<b>FLIGHT DESIGN</b>	<b>Service Bulletin</b>	
<b>Flight Design general aviation GmbH</b> Bertha-Benz-Straße 4 64625 Bensheim Germany web <a href="http://www.flightdesign.com">www.flightdesign.com</a> e-mail <a href="mailto:airworthiness@flightdesign.com">airworthiness@flightdesign.com</a>	<b>SB-ASTM-F2-03</b>	<b>Revision 00</b>
	Date of Initial Publication	<b>29-Jun-2026</b>
	Publication Date of this Revision	<b>29-Jun-2026</b>

## Improvement of Electric Ground Bus

**SB-ASTM-F2-03**

#### Step 2

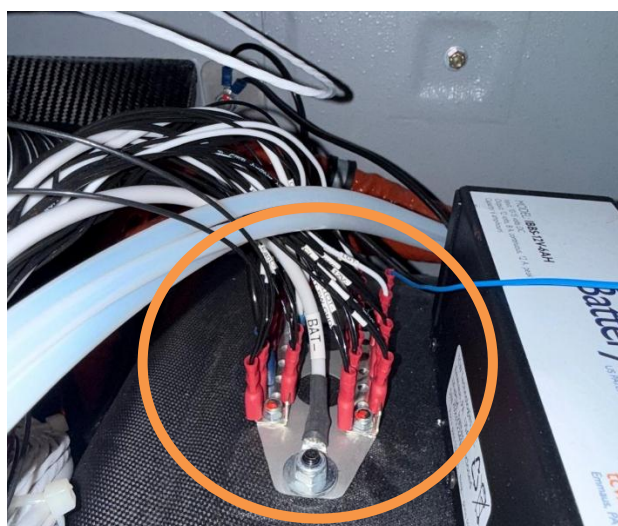
Take out the right GARMIN G3X screen (4 bolts, one in each corner) and disconnect the large Sub-D connector on its rear side.

Alternatively, the entire cockpit panel may be uninstalled.
